UNITED STATES
DEPARTMENT OF THE INTERIOR
BUREAU OF LAND MANAGEMENT

FORM APPROVED
OMB NO. 1004-0137
Expires: January 31, 2018SUNDRY NOTICES AND REPORTS OF WELLS
*Do not use this form for proposals to drill or to re-enter an abandoned well. Use form 3160-3 (APD) for such proposals.*JAN 21 2020
EMNRD-000ARTESIA

XTO Permian Operating, LLC requests permission to make the following changes to the original APD:

XTO Energy Inc.
PLU.18 Twin Wells Ranch #121H
Projected TD: 21670' MD / 11767' TVD
SHL: 75' FNL & 535' FWL, Section 19, T24S, R31E
BHL: 200' FSL & 330' FWL, Section 30, T24S, R31E
Eddy County, NM

13-3/8" x 9-5/8" x 5-1/2" 10M RSH-2 Wellhead
Assembly, With T-EBS-F Tubing Head

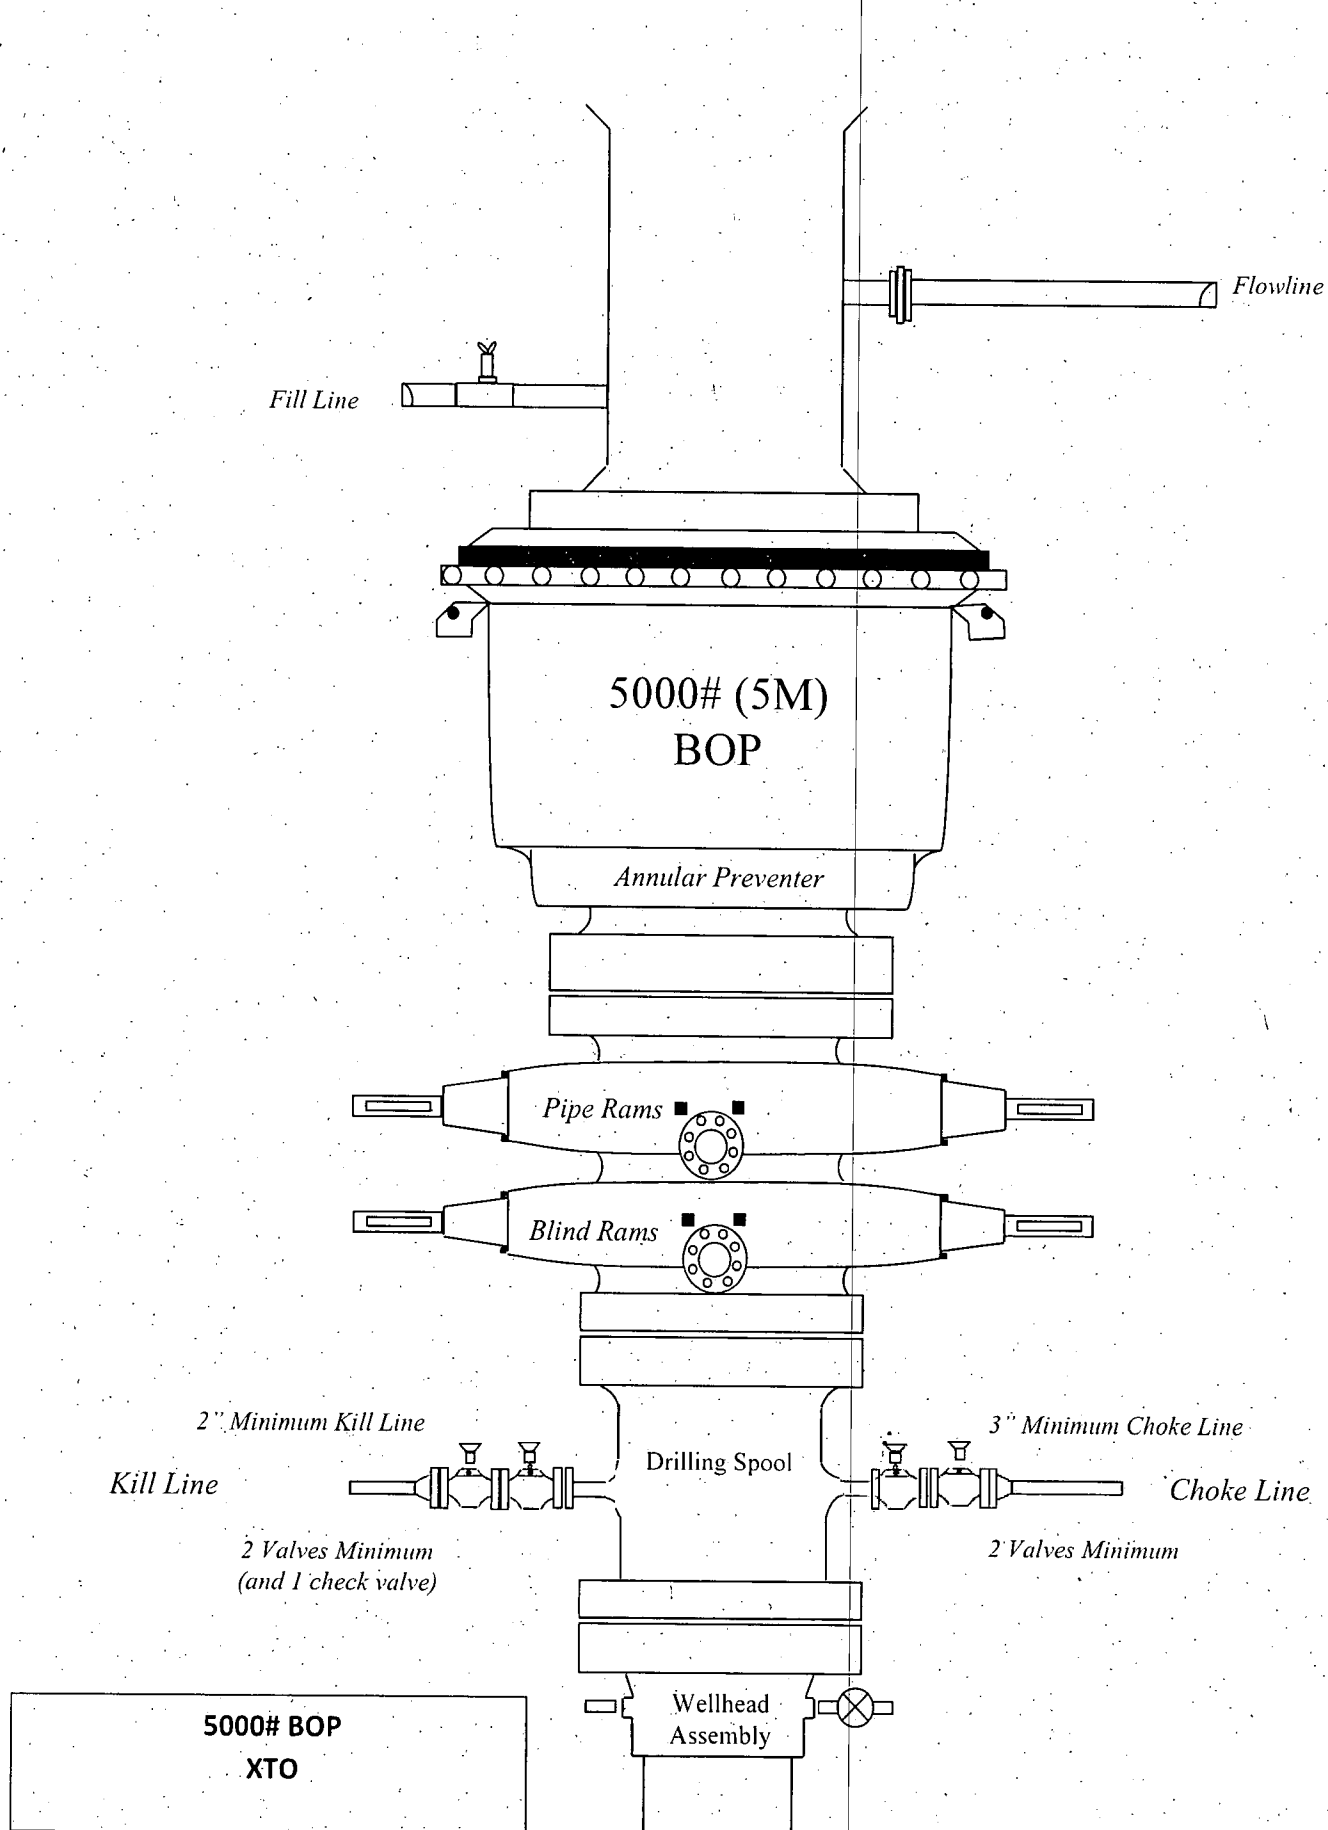
Permanent Wellhead - GE RSH Multibowl System

A. Starting Head (RSH System): 13-3/8" SOW bottom-x 13-5/8" 5M top flange

B. Tubing Head: 13-5/8" 5M bottom flange x 7-1/16" 10M top flange

- Wellhead will be installed by manufacturer's representatives.
- Manufacturer will monitor welding process to ensure appropriate temperature of seal.
- Operator will test the 9-5/8" casing per Onshore Order 2.
- Wellhead manufacturer representative may not be present for BOP test plug installation

3. **Operator has proposed a multi-bowl wellhead assembly. This assembly will only be tested when installed on the surface casing. Minimum working pressure of the blowout preventer (BOP) and related equipment (BOPE) required for drilling below the surface casing shoe shall be 5000 (5M) psi.**

- a. **Wellhead shall be installed by manufacturer's representatives, submit documentation with subsequent sundry.**
 - b. **If the welding is performed by a third party, the manufacturer's representative shall monitor the temperature to verify that it does not exceed the maximum temperature of the seal.**

- c. **Manufacturer representative shall install the test plug for the initial BOP test.**
 - d. **Operator shall perform the intermediate casing integrity test to 70% of the casing burst. This will test the multi-bowl seals.**

- e. **If the cement does not circulate and one inch operations would have been possible with a standard wellhead, the well head shall be cut off, cementing operations performed and another wellhead installed.**

5M Choke Manifold Diagram
XTO

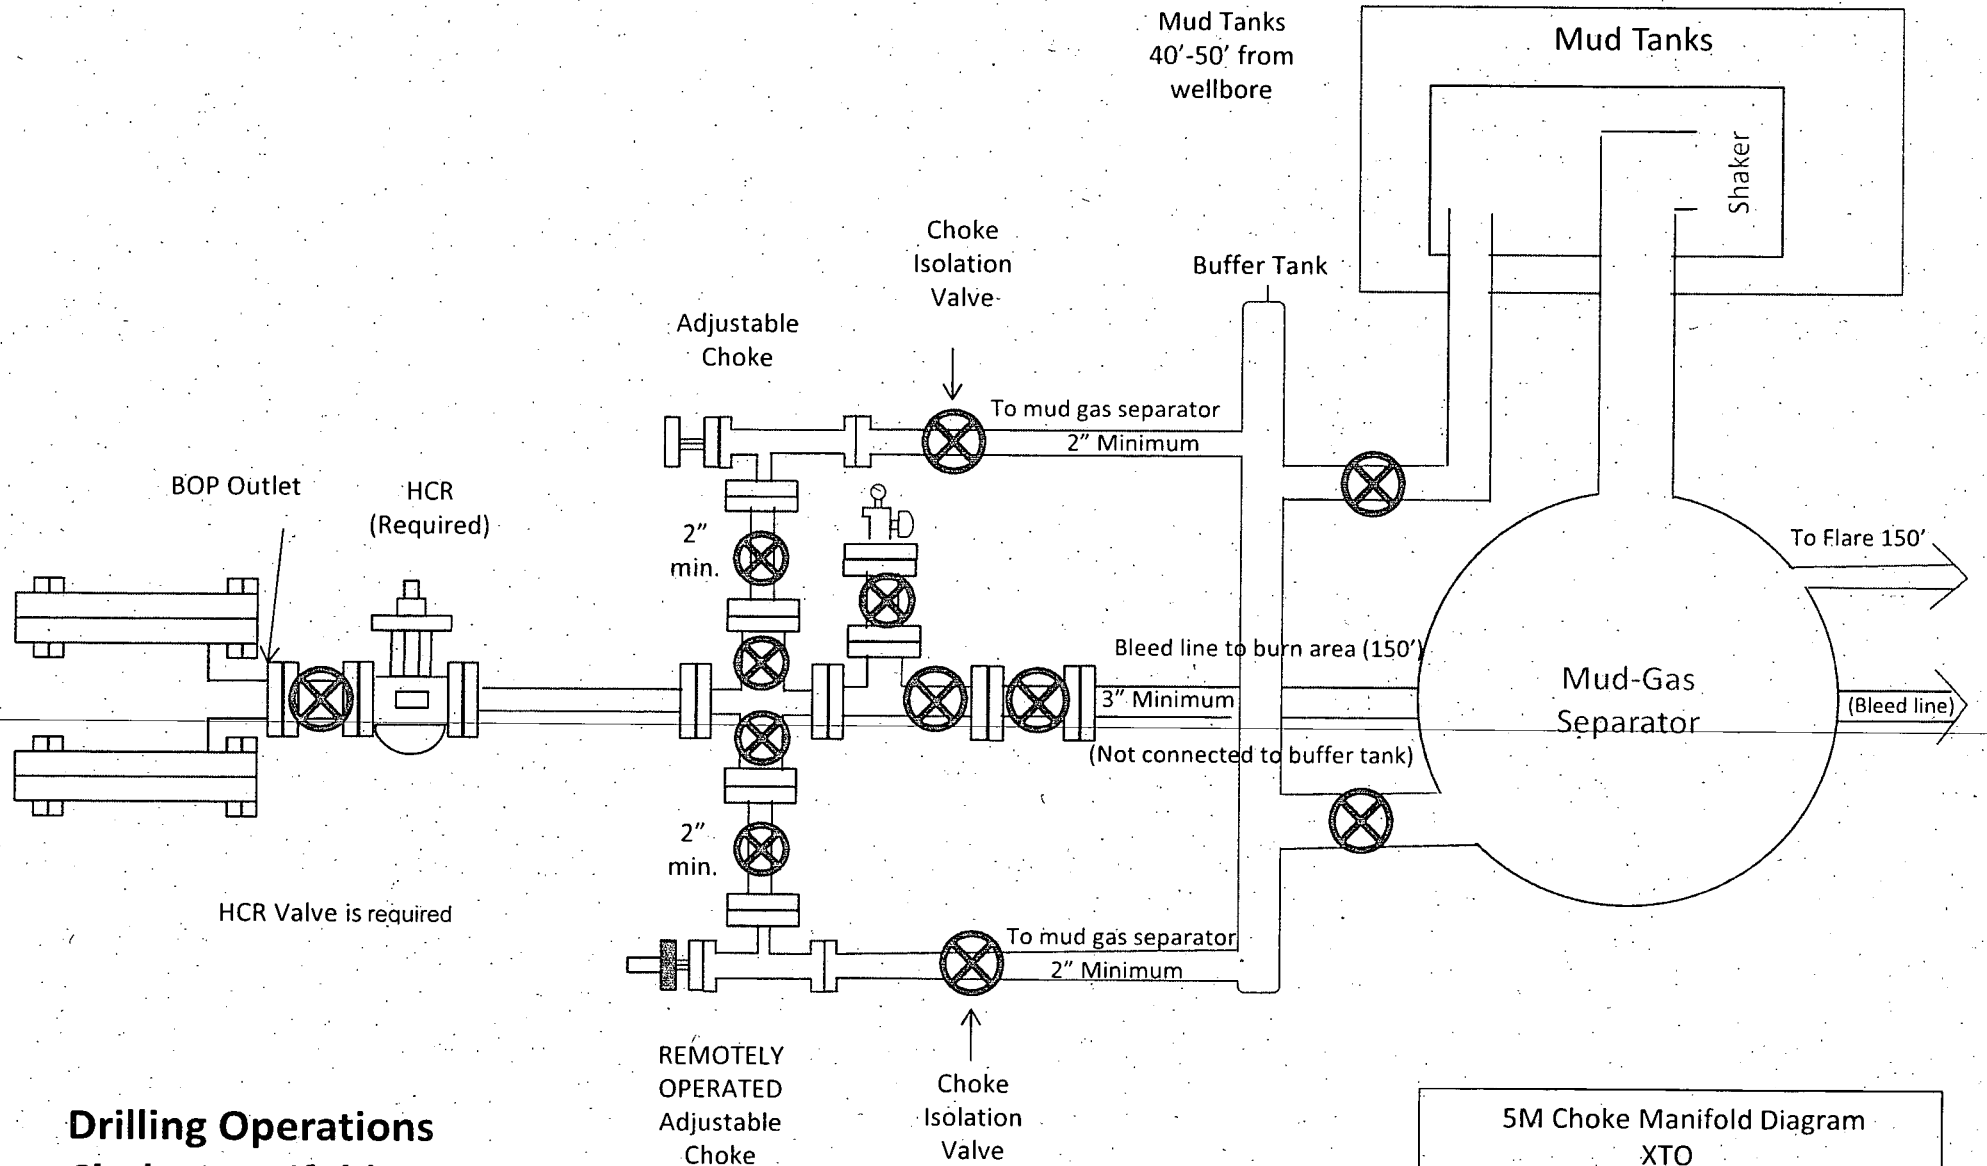
A variance is requested to allow use of a flex hose as the choke line from the BOP to the Choke Manifold. If this hose is used, a copy of the manufacturer's certification and pressure test chart will be kept on the rig. Attached is an example of a certification and pressure test chart. The manufacturer does not require anchors.

2. Variance approved to use flex line from BOP to choke manifold. Check condition of flexible line from BOP to choke manifold, replace if exterior is damaged or if line fails test. Line to be as straight as possible with no hard bends and is to be anchored according to Manufacturer's requirements. The flexible hose can be exchanged with a hose of equal size and equal or greater pressure rating. **Anchor requirements, specification sheet and hydrostatic pressure test certification matching the hose in service, to be onsite for review. These documents shall be posted in the company man's trailer and on the rig floor.** If the BLM inspector questions the straightness of the hose, a BLM engineer will be contacted and will review in the field or via picture supplied by inspector to determine if changes are required (operator shall expect delays if this occurs).

5M system requires an HCR valve, remote kill line and annular to match. The remote kill line is to be installed prior to testing the system and tested to stack pressure.
